Subject: development at 4 Vickers Road, Hamilton - 25T-202004

Subject: 4 Vickers Road, Hamilton - Proposed Redevelopment - Further Questions

Subject: Parking Issues at Linden Park Development

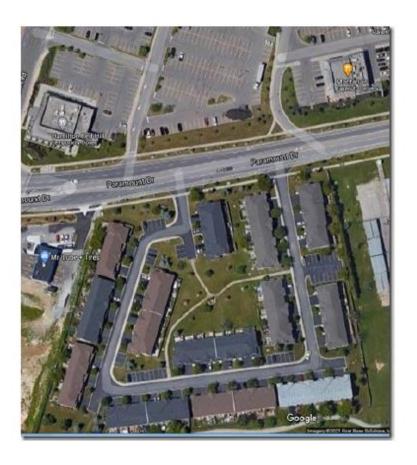
Hi Mike, from the attached presentation it looks like this development will have enough room for at least two cars in the driveway. Is this an accurate representation of the Proposed development? If not why was it used in the presentation?

If the driveways in fact only provide enough room for one car, then I think the buildings should be set back to provide this additional driveway space.
